**KANEPACKAGE PHILIPPINE INC.**

INVESTIGATION REPORT FORM (IRF)

Customer	BROTHER INDUSTRIES PHILIPPINES, INC.	Attention To	REXEL ALMARIO
Item Code	D038PE001	Department	PRODUCTION
Item Description	CARTON MFC-J1260W US/CAN-C	Date of Detection	260131
Job Order Number	JO26-M-00113-61A	Section Detected	QA SCREENING

ILLUSTRATION OF THE PROBLEM

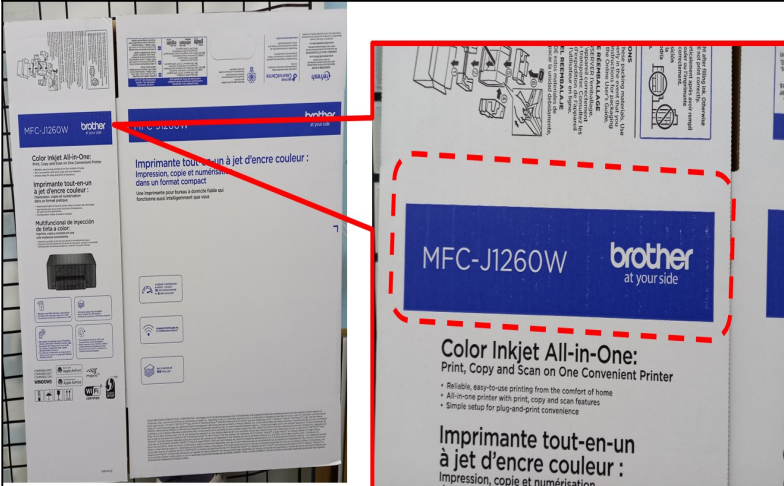
Nature of Defect:

POOR PRINT

Requirement:

No poor print

Actual

With poor print

WHY 1 : uneven distribution of ink in the item

WHY 2 : insufficient pull nip pressure during operation

WHY 1: Cascade to EQOS Operators the checking of machine set up prior mass pro and thorough checking of output during mass pro to ensure to eliminate or lessen such poor print
